Report: ISSUES

Function: Test, Adjust, & Balance

11-27-23 CULVERS-DELANO, MN

Incorrect
11/27/2023

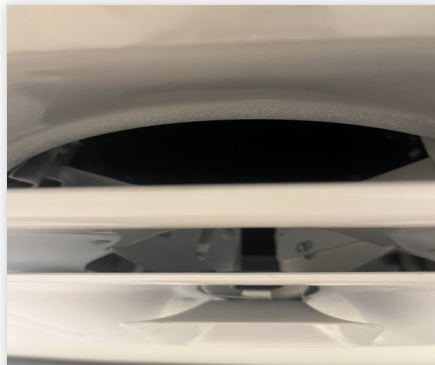
Issue Name : PRV-1 (RR Exhaust) Incorrect Grilles Installed
Description : Installed Exhaust grilles in bathroom are supply grilles (SD-4). Plans call for EG-1 return grilles with OBD face damper. Installed grilles do not have have face damper and cannot be balanced. Recommend correct grilles are installed.
